TO: Jessica McCallum, Kevin Roth, Kimley-Horn
FROM: Amber Wood Hicken, Planner I
DATE: 11/09/23
SUBJECT: Parker Pointe F1 Lot 2A, McDonald's – Site Plan, SP23-070
Review Comments 01

PARKER POINTE SUBDIVISION FILING NO. 2, LOT 2A

SITE PLAN

SITE PLAN

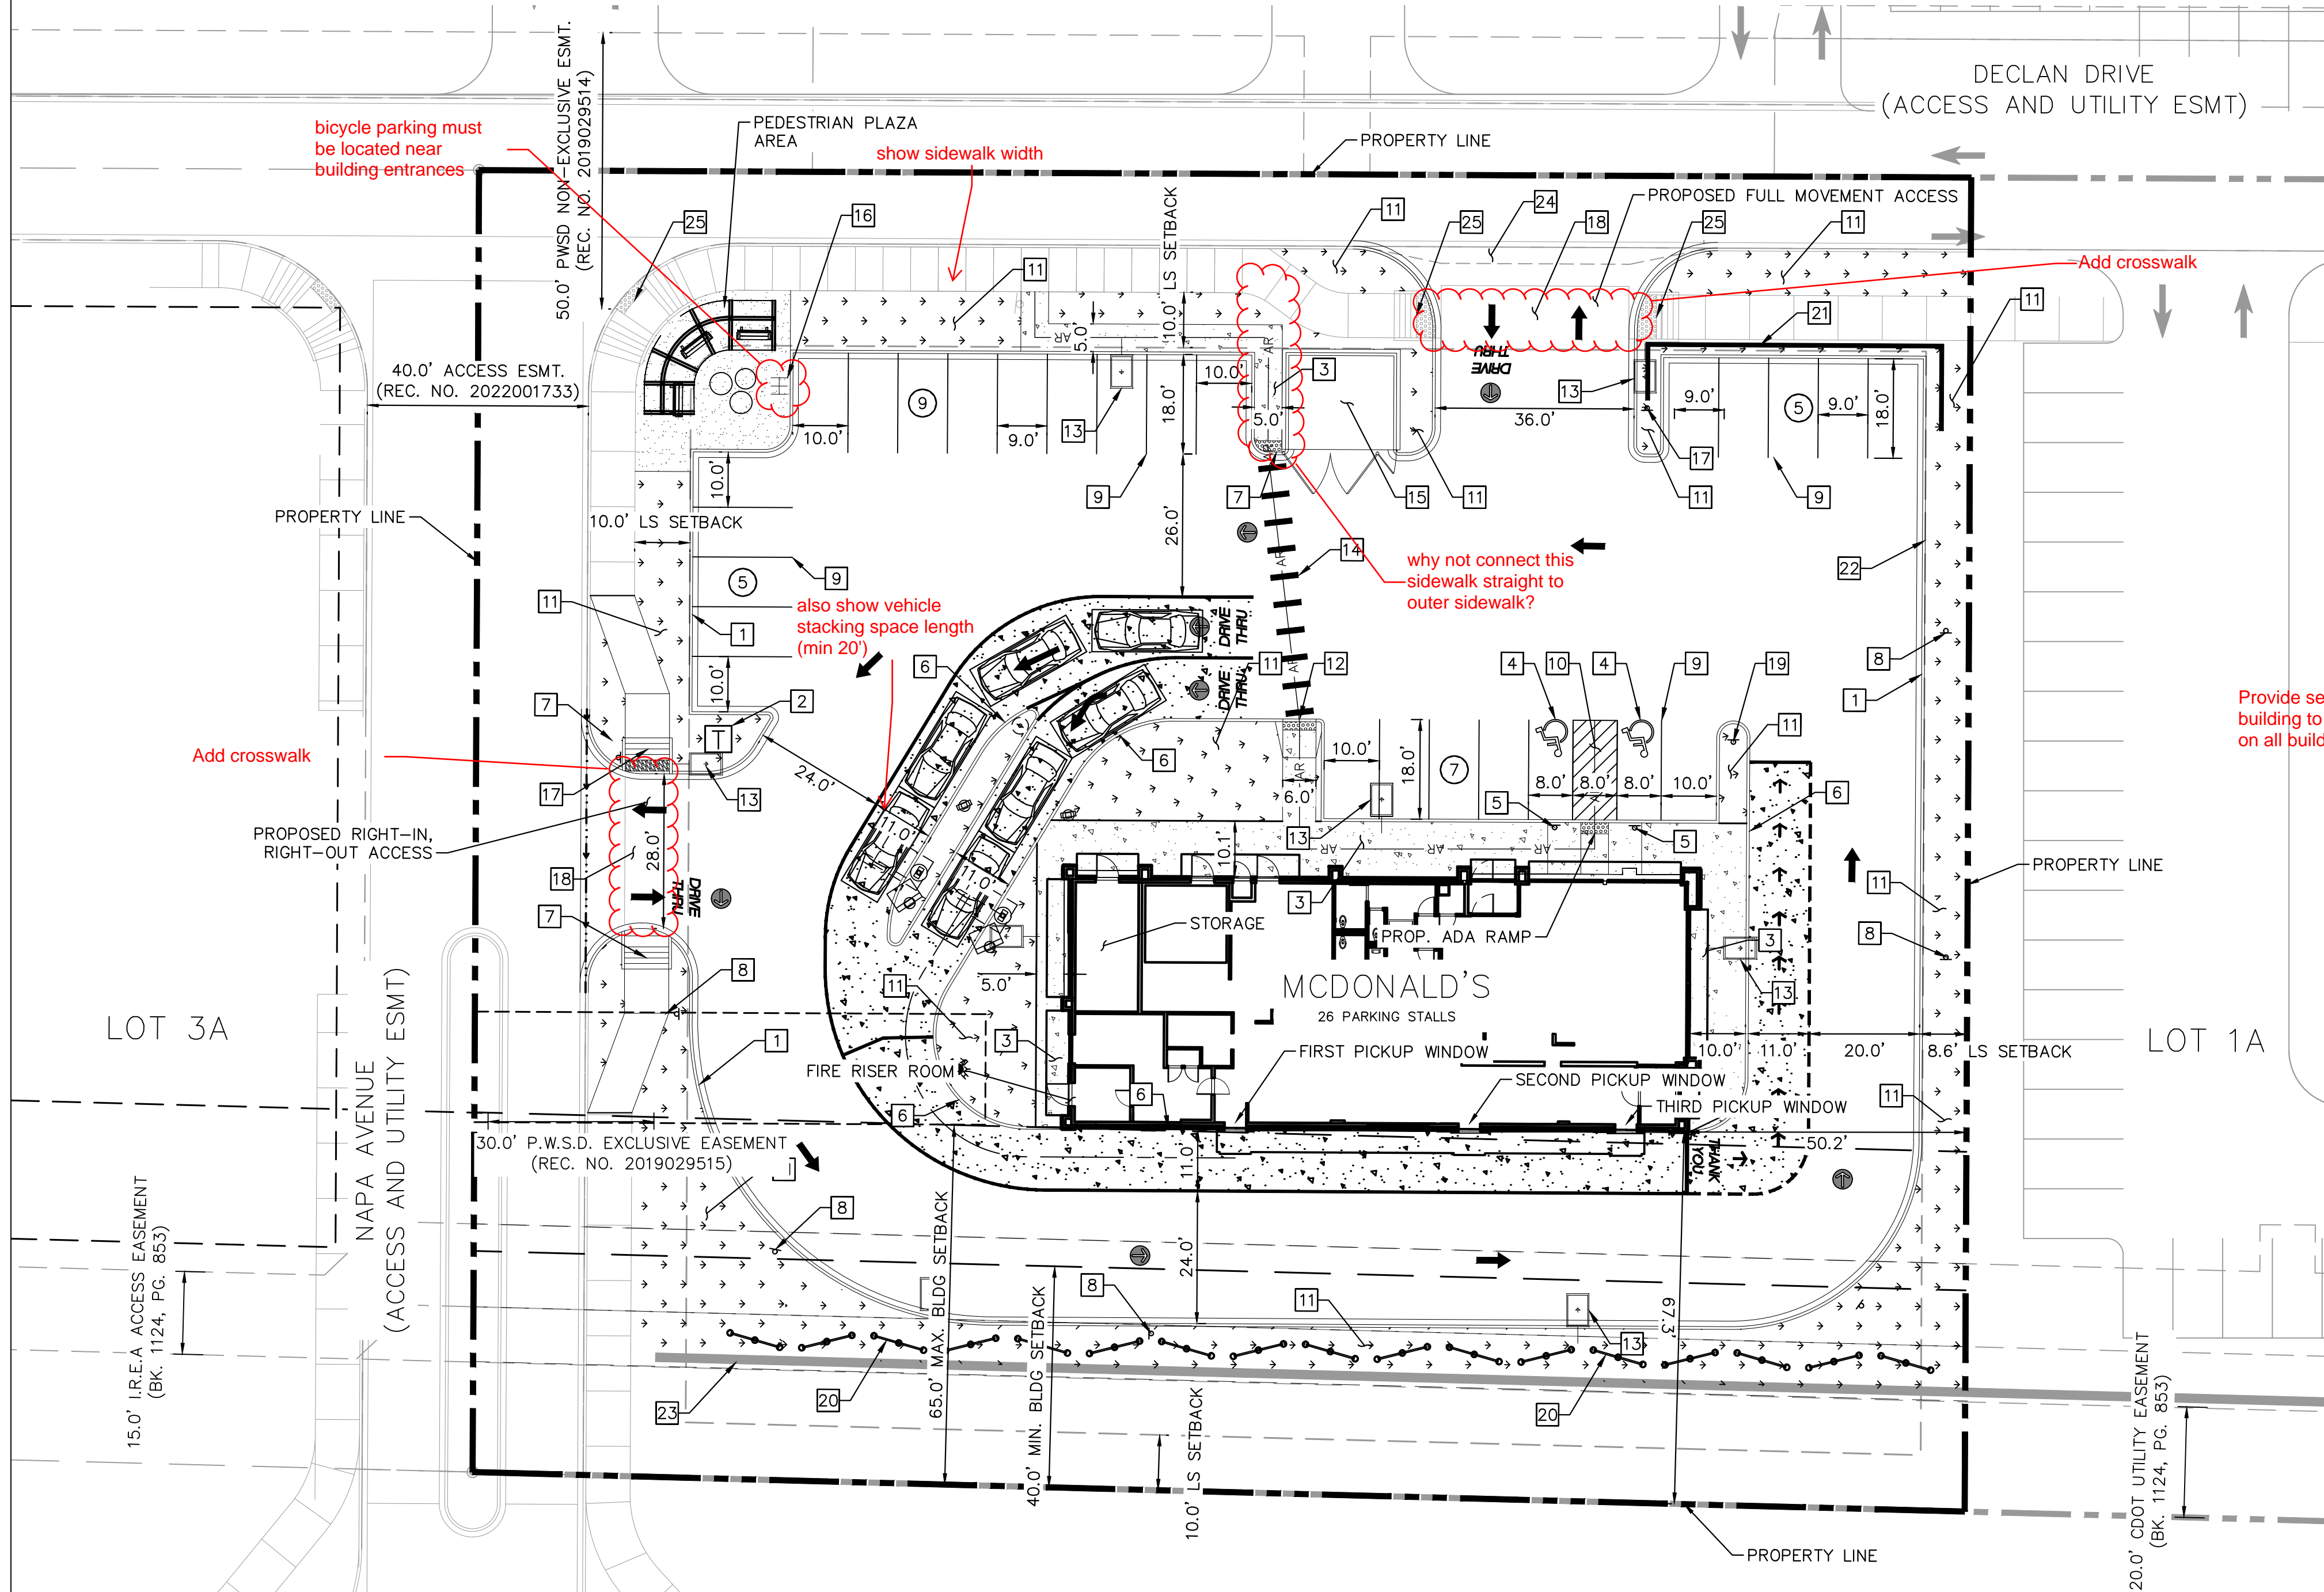
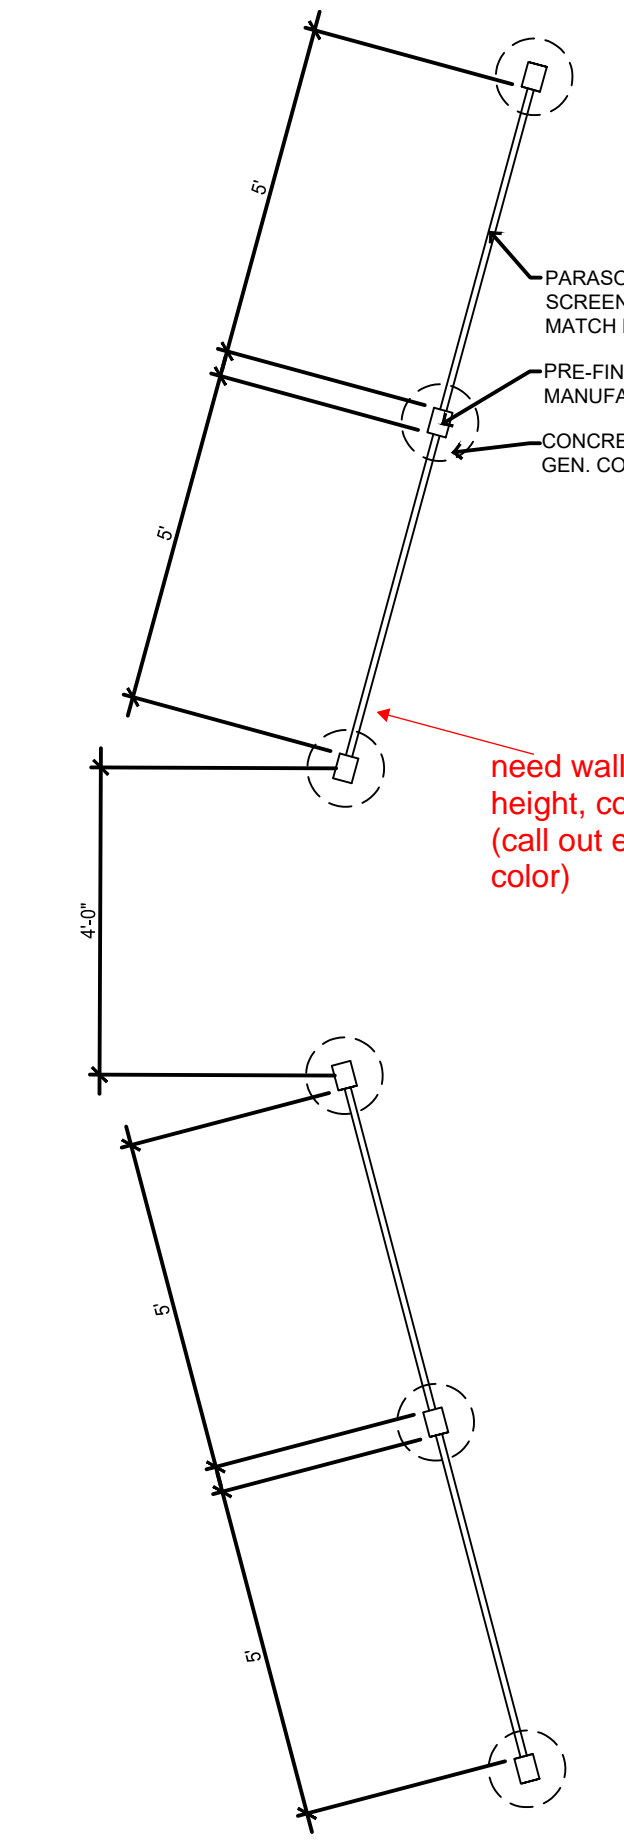
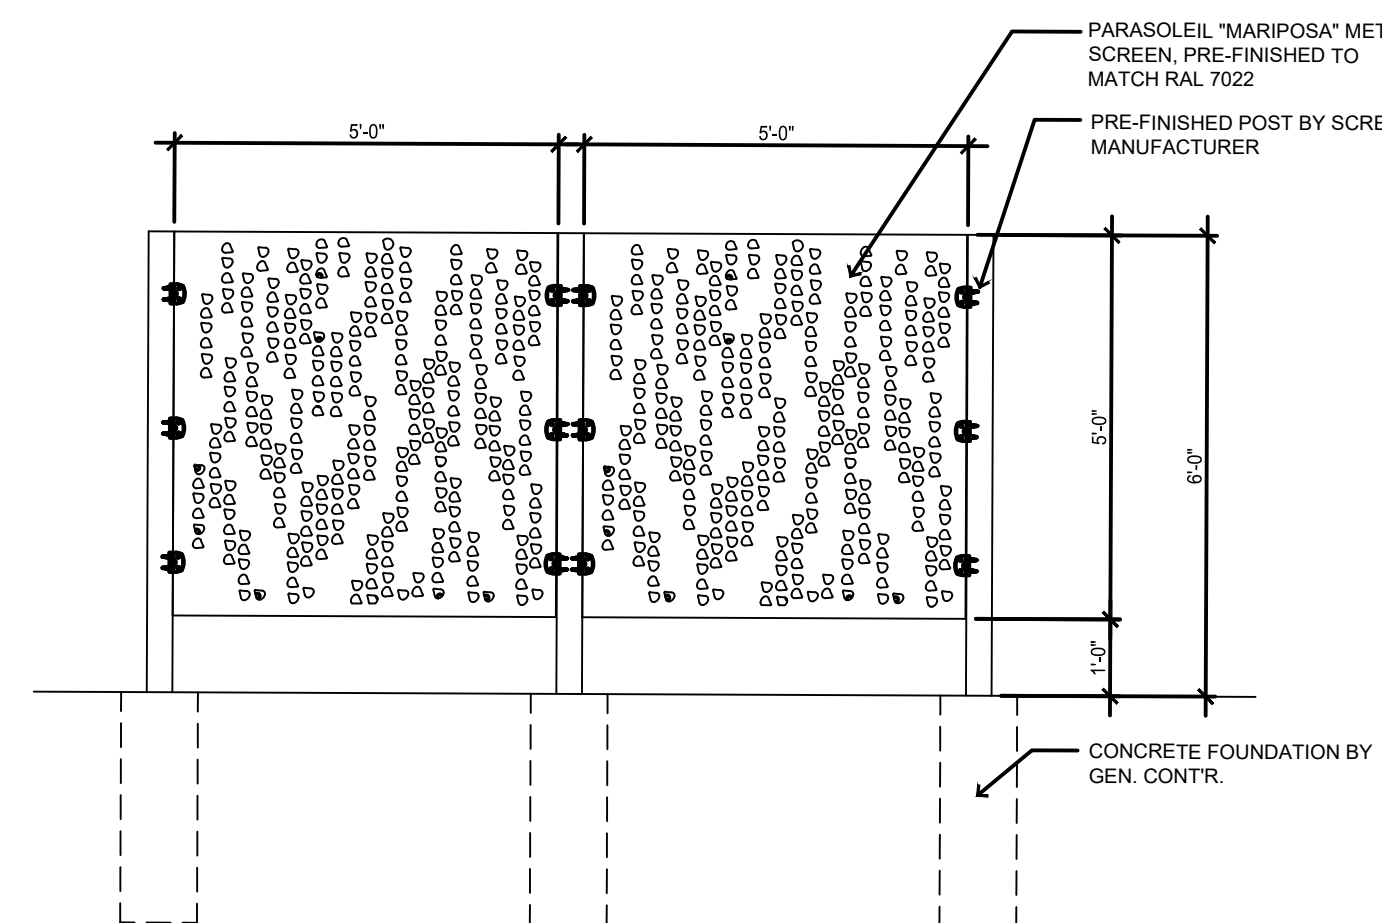
need wall height, color (call out exact color)
details needed for retaining wall - materials, height, color

| 8 | PROPOSED "NO PARKING FIRE LANE" SIGN | 23 | EX. RETAINING WALL ← please provide height of existing |

LANDSCAPE PLAN

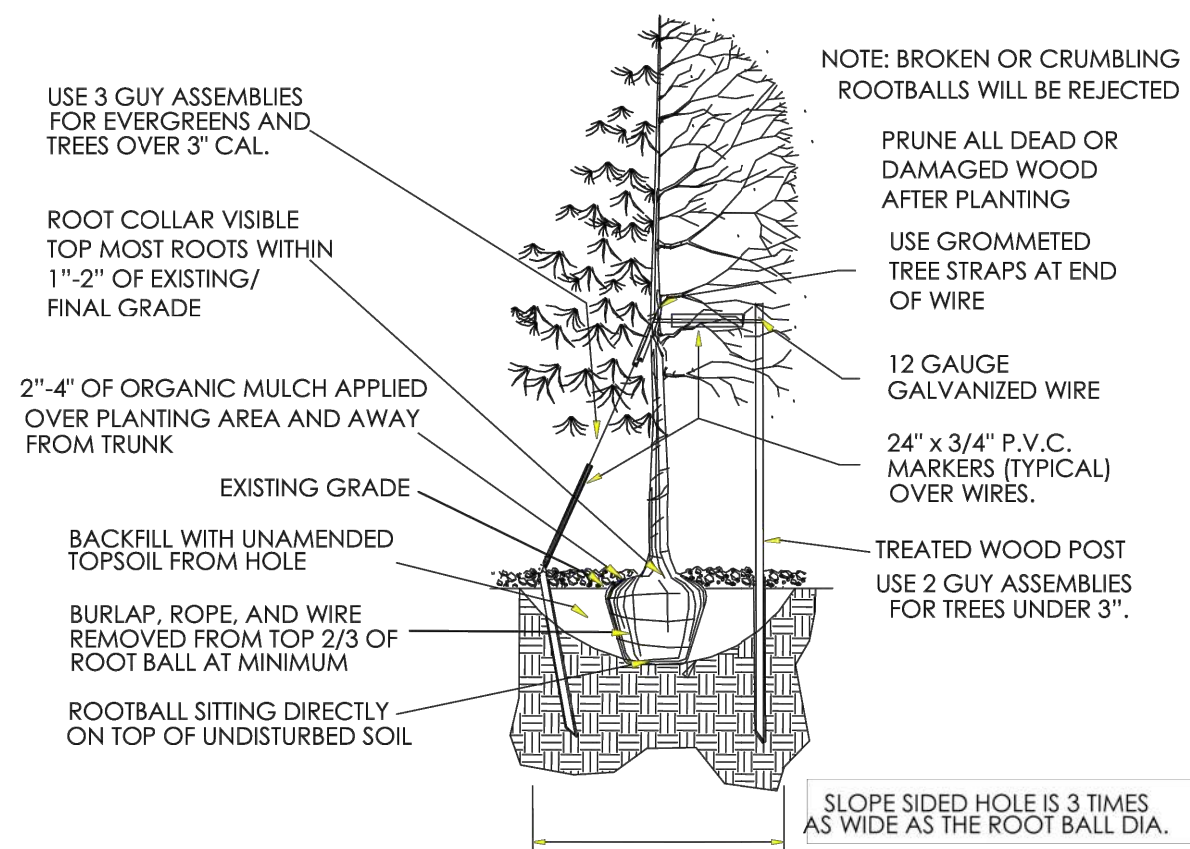
see previous sheet for clouded areas

changes needed to this chart (show required / provided):
EASTERN property line - parking lot perimeter standards

cover sheet shows 64,609sf

plant schedule shows 20 trees provided

plant schedule shows 252 provided
